18 February 2015

**Liddell Road Plans**  
**Ref: 2014/7651/P and 2014/7649/P**

**Proposed Section Through  
75 Maygrove Road**

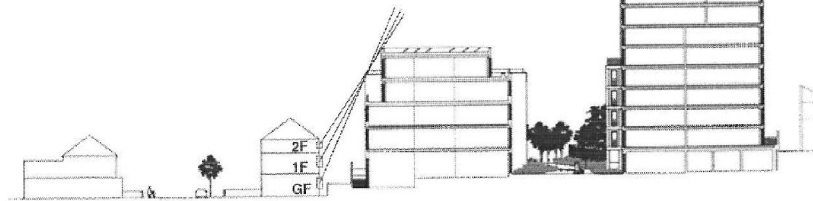
1. I understand that the plans include tower blocks, and that at least one of them is intended to be 11 storeys high. Given that this development is immediately behind our offices, this building will inevitably seriously affect the light available to our business through the windows we have at the back of our office. Our building is only 3 storeys high and we enjoy the natural light which we presently benefit from. The first image on page two clearly indicates the existing condition with adequate light levels. The proposals in the second image on page two represent an unacceptable level of overlooking with the best case on the 2<sup>nd</sup> floor comprising a level of light substantially worse than the existing condition on our ground floor.

substantial changes proposed to existing ground level within extremely close proximity to the rear of our existing property - to be excavated with waste material removed from site

GF - Rights to light angle = 50°  
1F - Rights to light angle = 32.75°  
2F - Rights to light angle = 14°

GF - Rights to light angle = 66°  
1F - Rights to light angle = 61°  
2F - Rights to light angle = 56°

My company has been at 75 Maygrove Road since this property was built in 2001/02 and feel that the loss of light would seriously diminish our use of the property. As can be noted within the above proposed section, extracted from the drawings issued as part of the application, the development represents an overbearing structure that will materially affect the internally space impact on its suitability. The rear windows currently provide adequate natural light levels for our required use, promoting a healthy working environment; however the proposals will create an insalubrious working environment impacting on the health and wellbeing of our longstanding workforce and the viability of our office space.

Additionally the level of excavation required within close proximity to our building is of concern. This will cause substantial disruption to our working environment due to the unacceptable increase in heavy trucks accessing the site to remove excess material. We would also question the environmental credentials of a scheme that requires such substantial ground works. We understand this has been proposed to minimise the height of the tower blocks. We would however suggest, that substantially reducing the height of these structures would be a more suitable solution as it would not burden the local infrastructure with the substantial level of trucks and heavy machinery required to complete these works.
